HARRISVILLE CITY

RE: 2550 NORTH 750 WEST COMMERCIAL SITE

Preliminary Site Plan Review

CONSTRUCTION DOCUMENTS HARRISVILLE CITY, WEBER COUNTY, UTAH

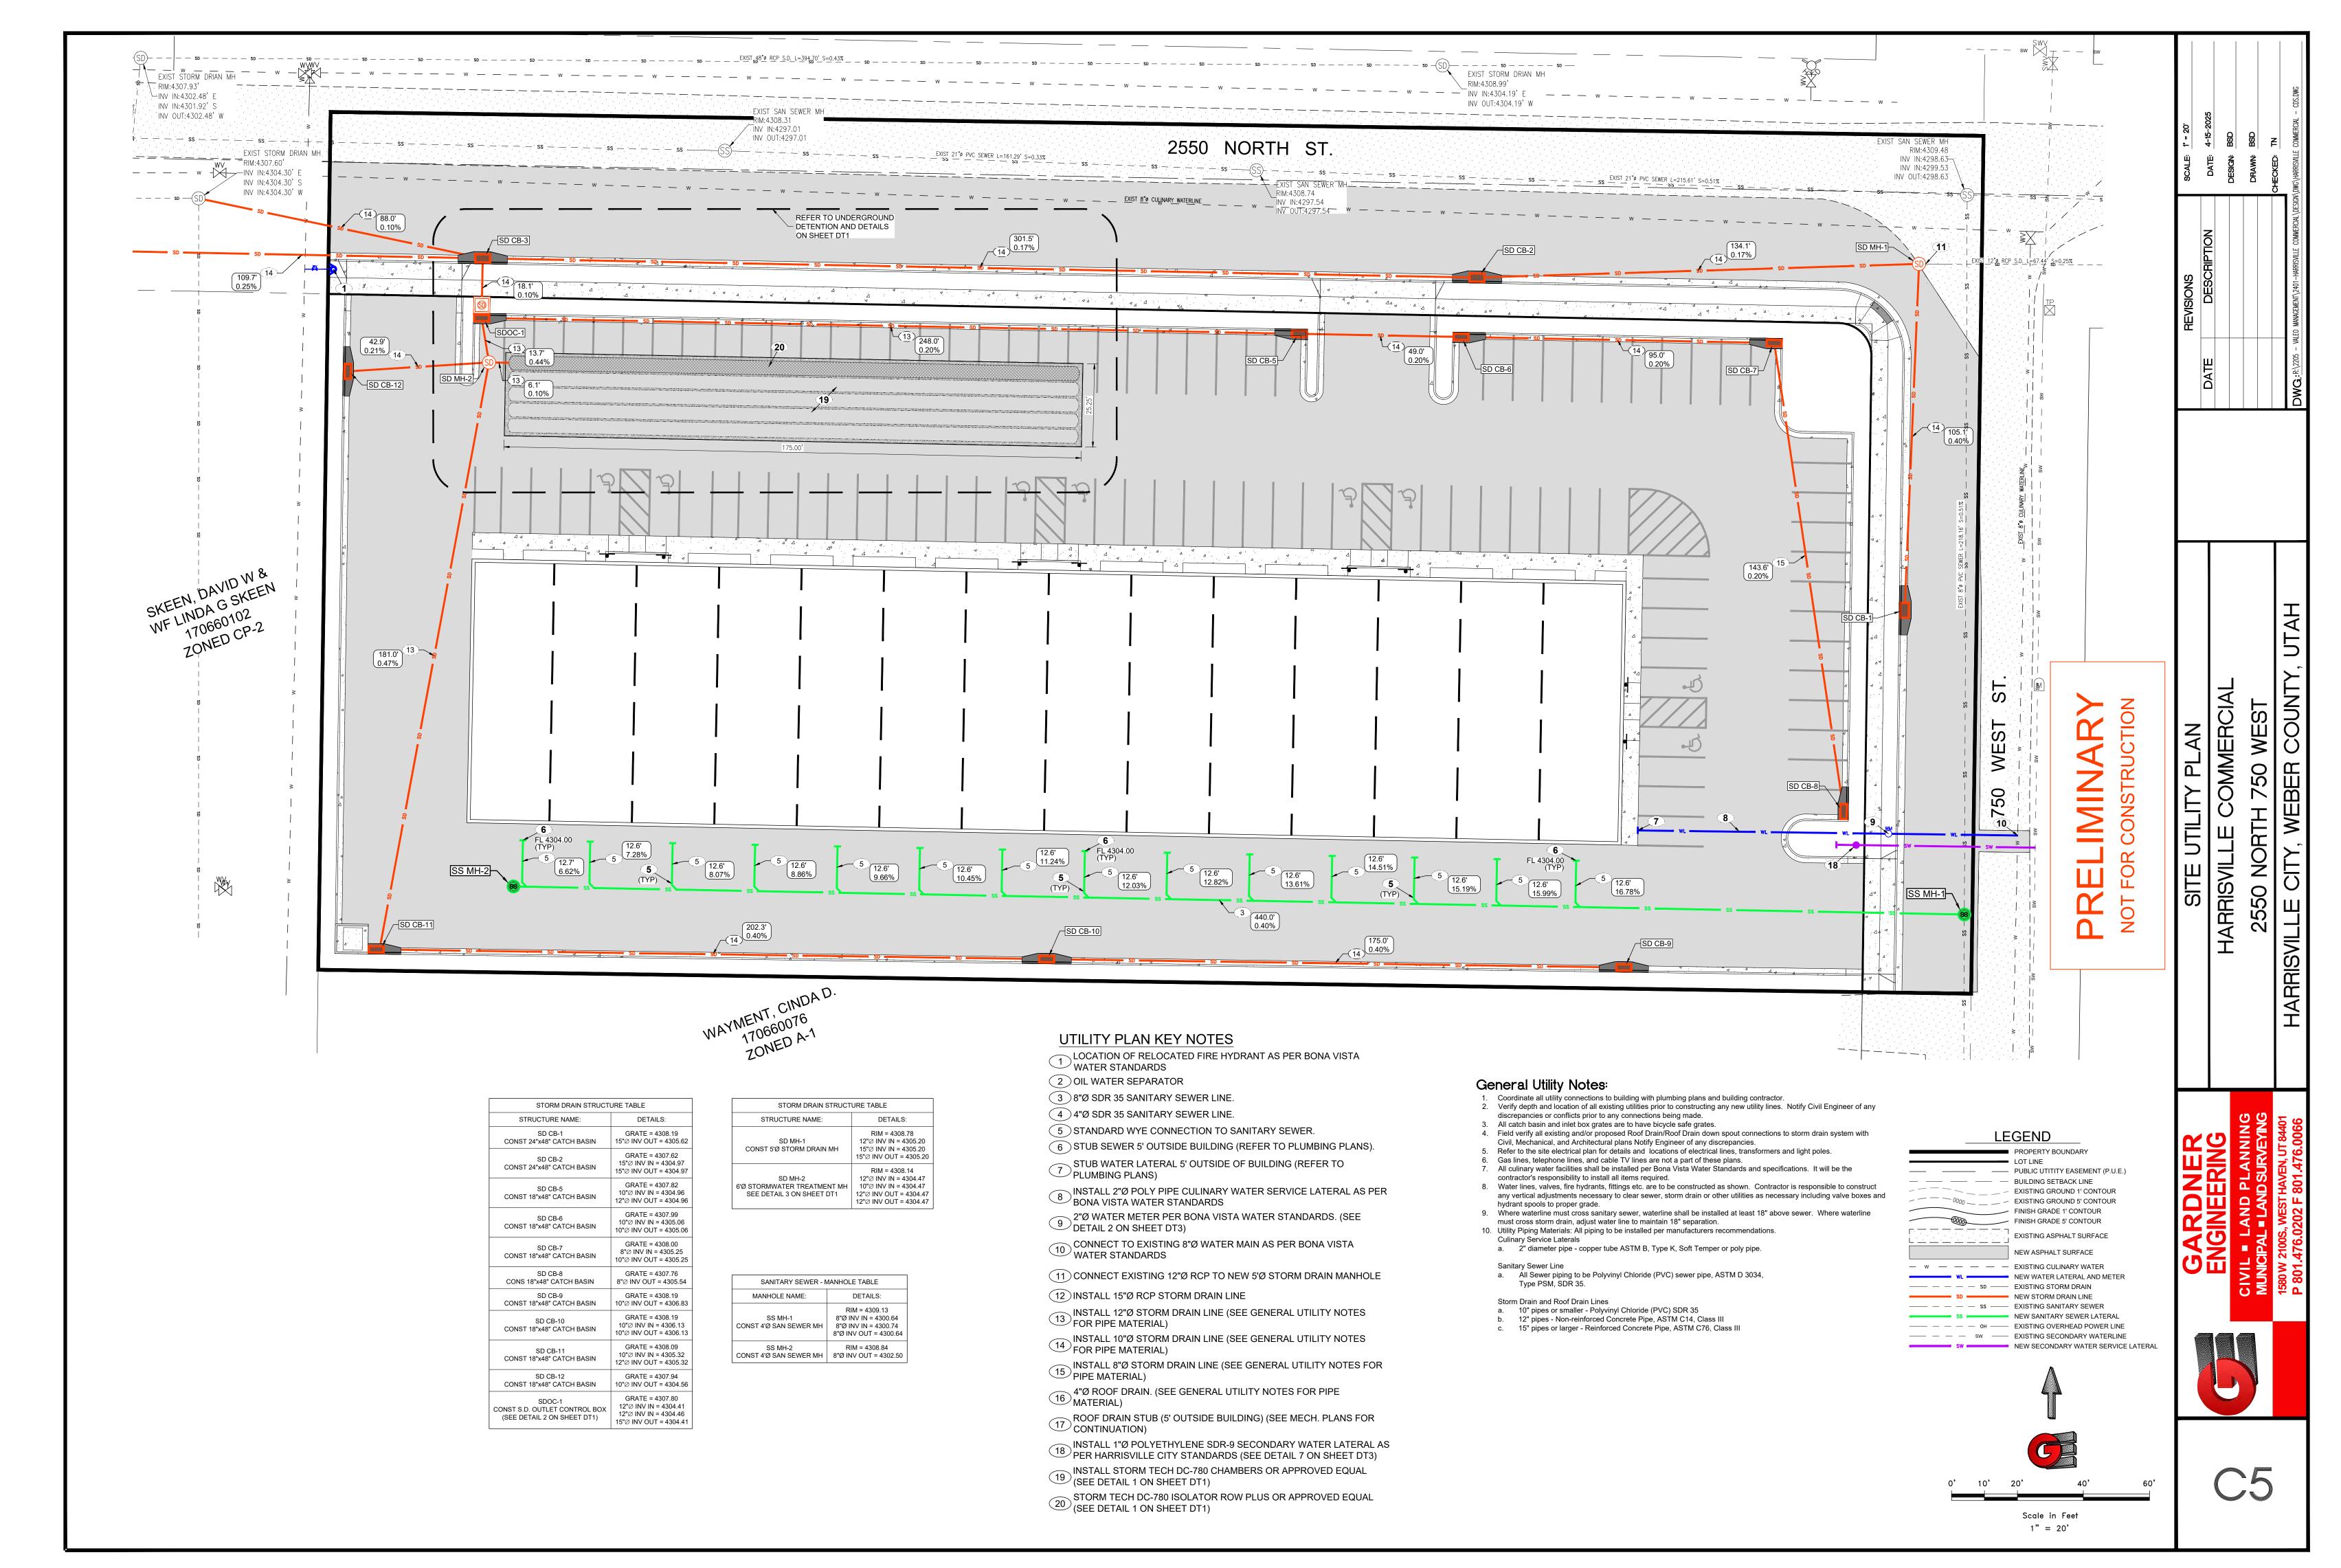
- 1. Rear parking lot setback should be 15 feet.
- 2. All improvements along 2550 North will need to be approved by Pleasant View City and will need to follow their standards.

- 3. Update the pavement section on 750 West to follow the City Standards (4" HMA, 6" UTBC, 12" GB).
- 4. Provide a landscape plan for the site per city code 11.13.040.

- 5. Call out the type of fencing shown to ensure that screening requirements are met.
- 6. Update the storm drain design and calculations to follow the City Standard of an allowable release rate of 0.1 cfs/acre.

- 7. The trash enclosure floor should be sloped; see city code 11.20.230.
- 8. The west drive approach on 2550 North and south drive approach on 750 West are too close to the existing drive approaches on adjacent property; see city code 11.13.030. Check Pleasant View code as well for spacing requirements.

- 9. Provide details for any signage that will be used, see city code 11.23.
- 10. Check with Weber Basin Conservancy District and ensure that the improvements are allowed within the source protection zone of the well on the adjacent property.

- 11. Revise site plan drawings per red-line comments on the plans.
- 12. Provide approval letters from Pleasant View City, Bona Vista Water, Pineview Water, North View Fire District, and Weber Basin (well).
